Access Compliance Report

Public Rights-of-Way

(Curb Ramps)

Intersection ID: N/A	Main Street: S_DAVIDSON_ST	Cross Street: N/A	Location: S
ADA ID: EBAFC1D4E208	Ramp Type: BlendTrans1	Initial Pass/Fail: Fail	Overall Compliance: No
Severity Score: 1.25			
Codes/Mitigation Info/Possible Solution		Field Measurements/Component Compliance

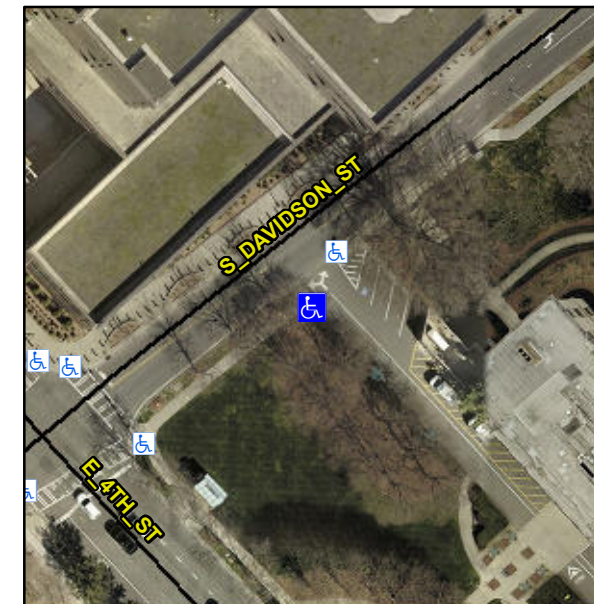
Not Found, R304.5.3

Remove & Replace Curb Ramp With Two New Directional Ramps or Equivalent.
